Design Review Board Study Session

SUBJECT: DR14-33, PADS B AND D AT AZ AVE WINCO

DR14-33, Pads B and D at AZ Ave Winco: site plan, landscape plan, grading and drainage, elevations, floor plans, lighting, colors and materials for approximately 2.0 acres located at the northeast corner of Arizona Avenue and Desert Lane zoned General Commercial (GC) with a Planned Area Development (PAD) overlay.

EAST ELEVATION (PAD B)

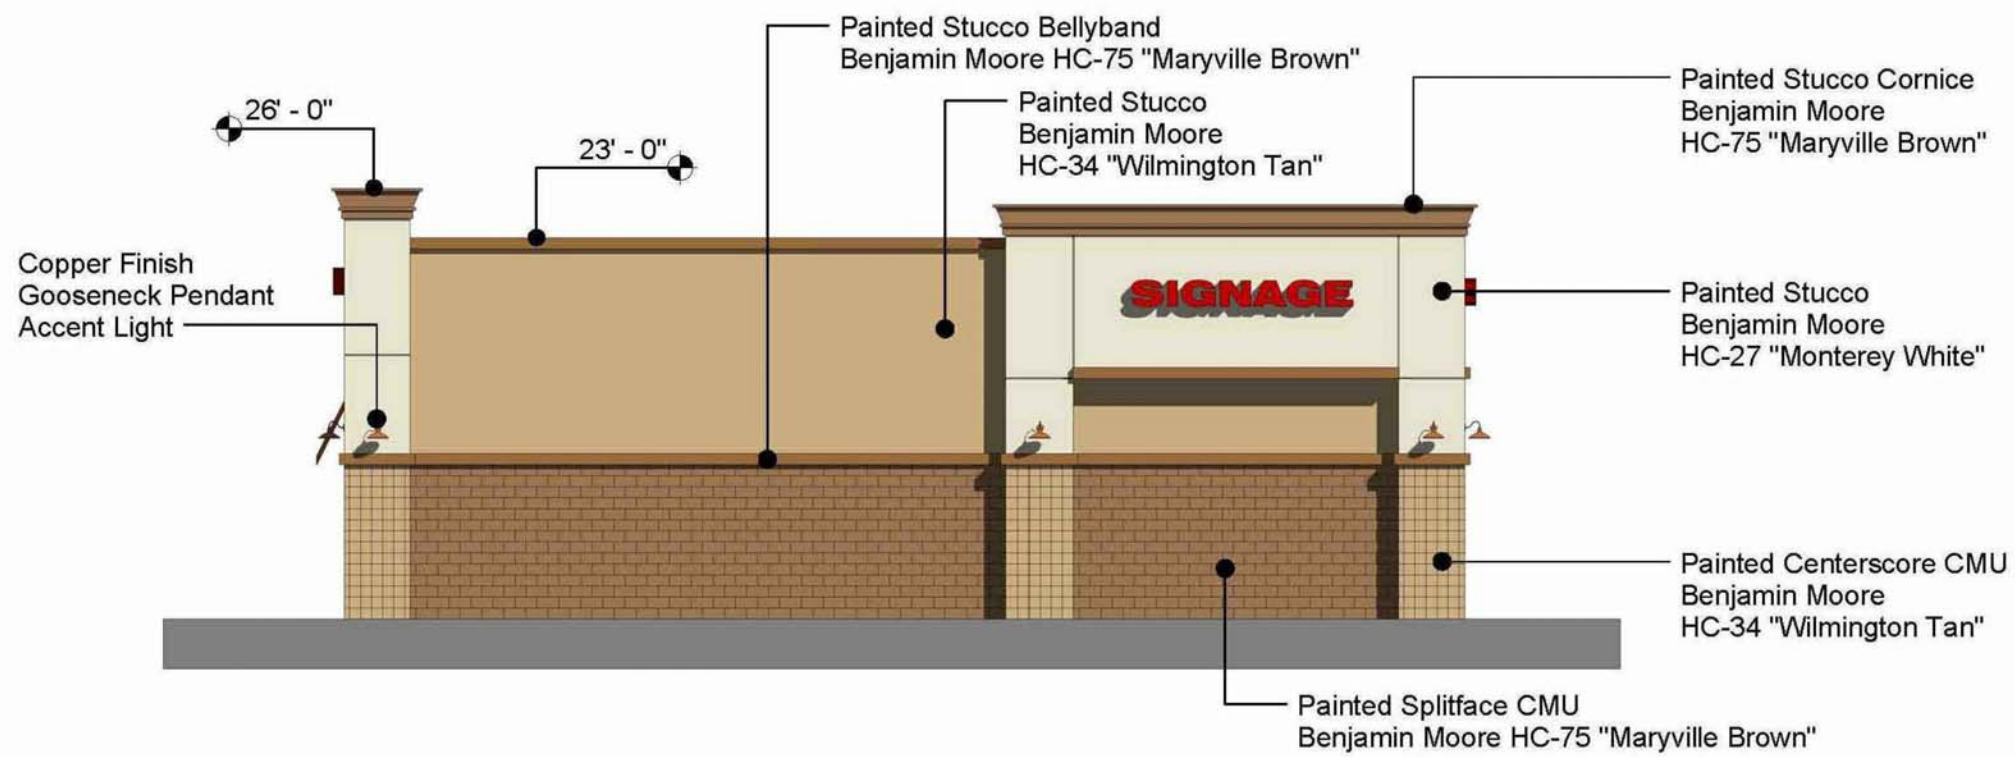
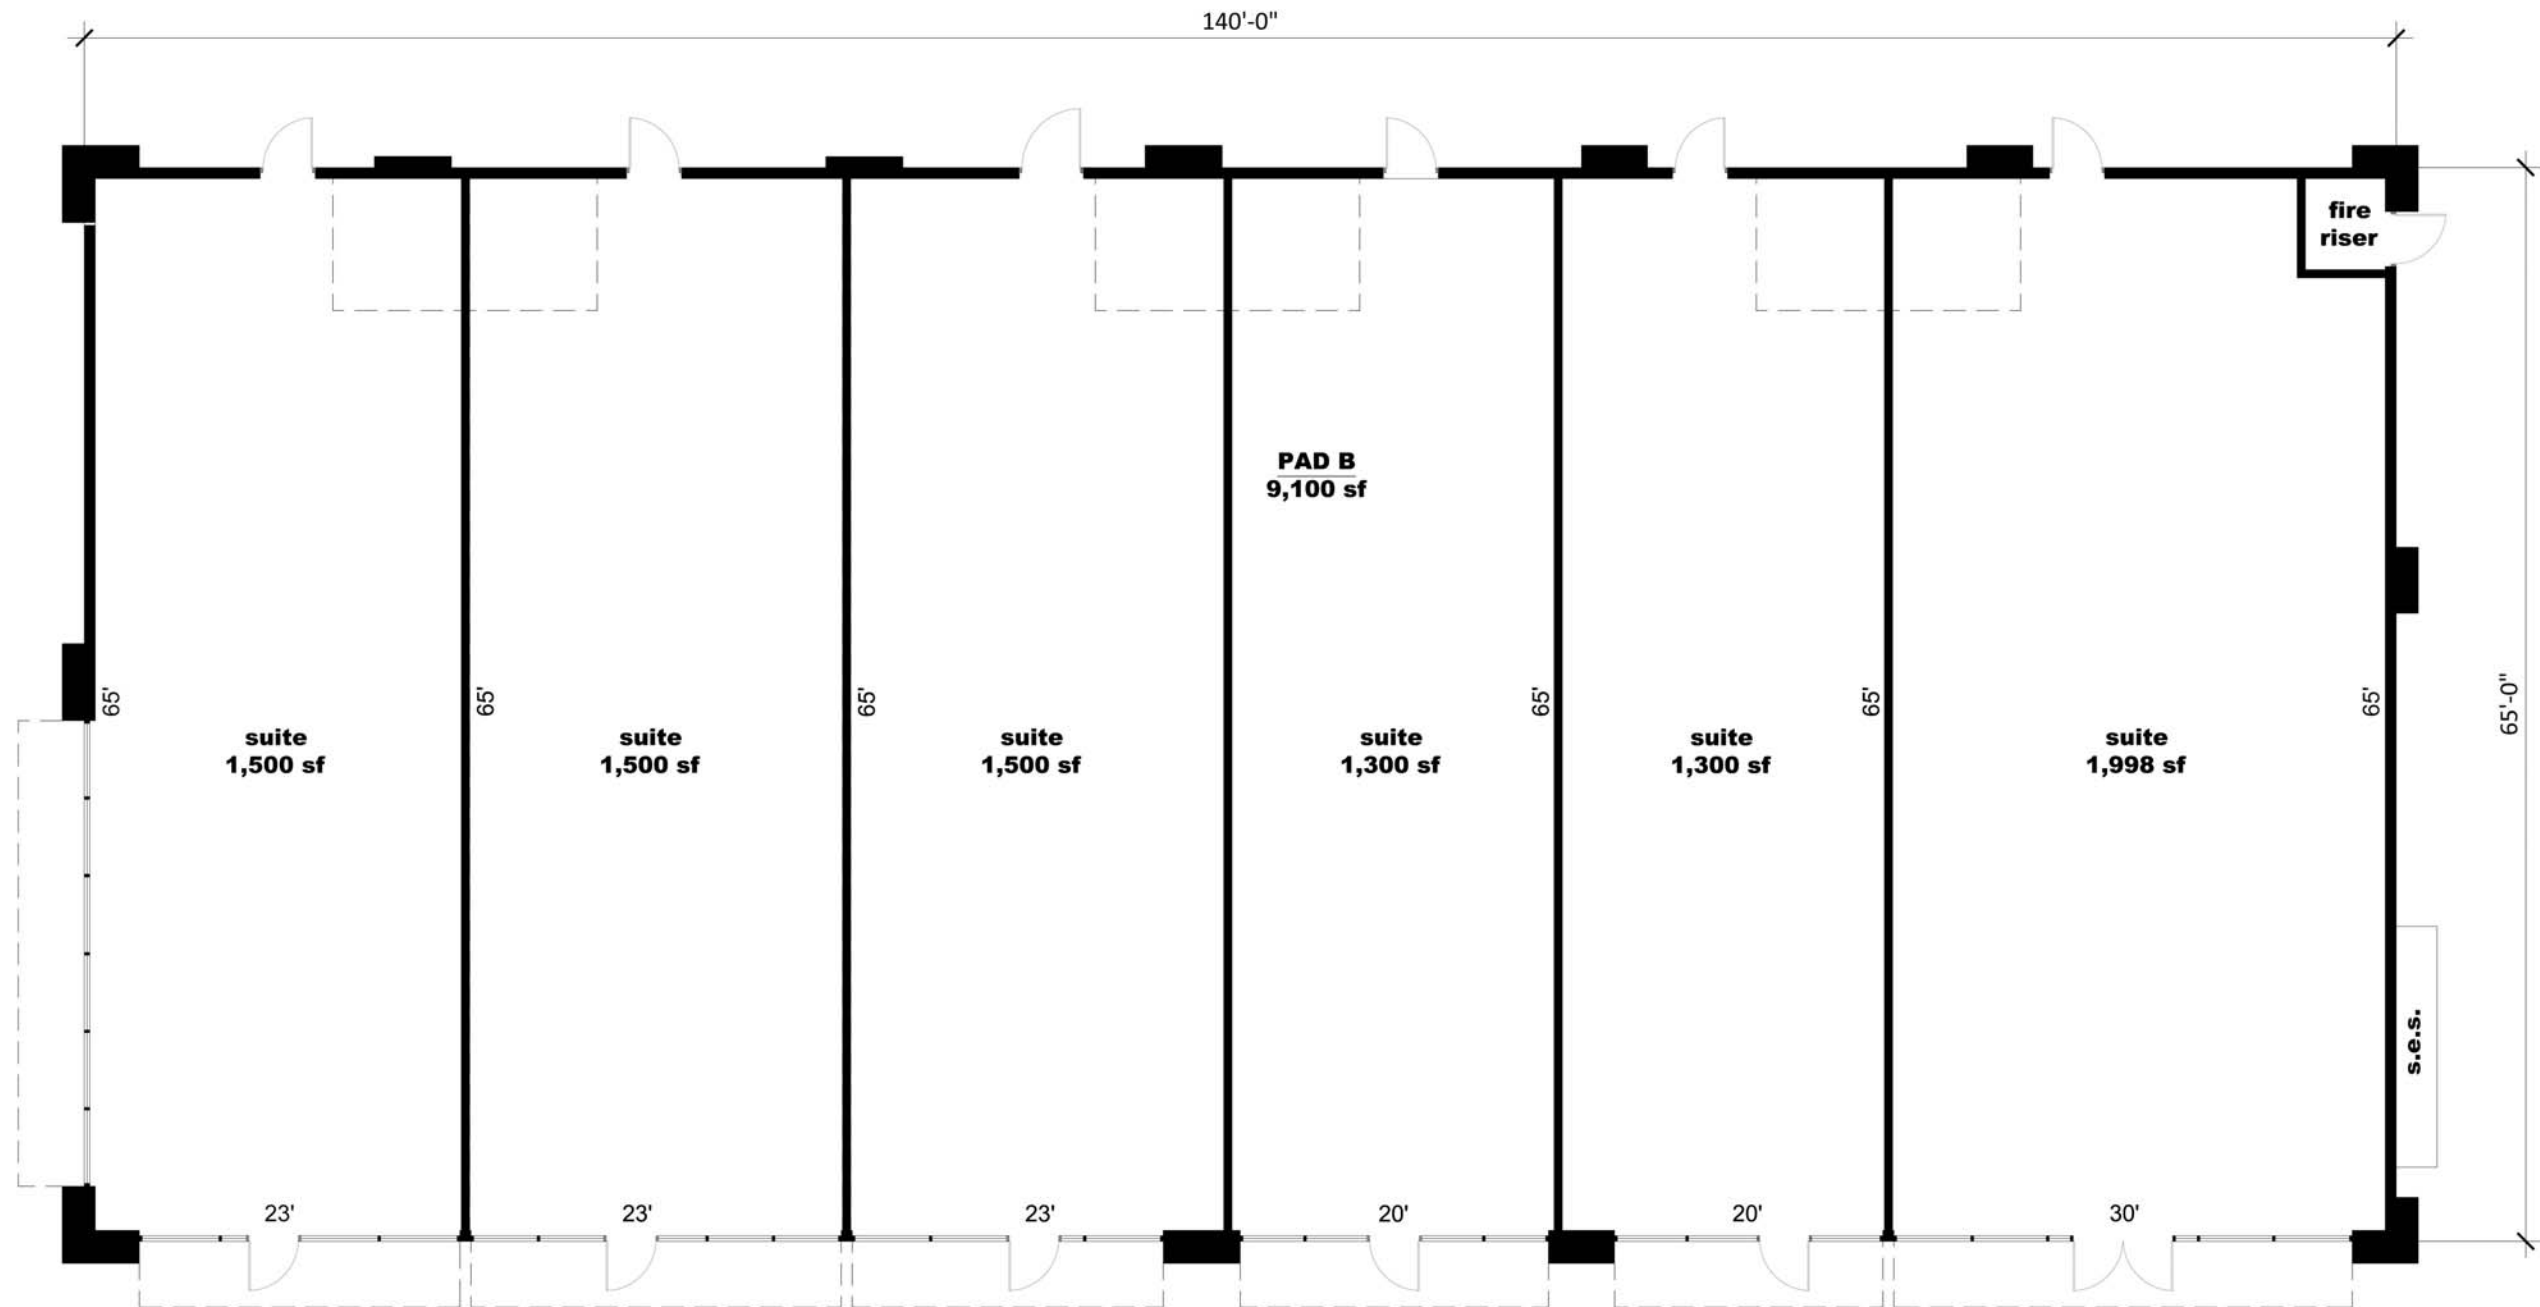
The east elevation of Pad B is in keeping with the Winco design, colors and materials. The elevation has vertical and horizontal movement and lots of glass store front. It appears from scaling the images provided that the horizontal change is between 1' and 2'. The vertical change is from 22' to 26' to 28' to top of parapet. The west, rear, elevation has horizontal movement and vertical movement with changes in color and material. With the mature vegetation along Arizona Avenue, there will be limited visibility to the rear of this building. However, staff will request that the rear doors be painted Maryville Brown to blend in and match the adjacent painted CMU. As stated above, staff supports the addition of a sidewalk along the north building elevation or the idea of a center plaza space to provide for outdoor options especially considering there are no other major plaza spaces within the entire shopping center.
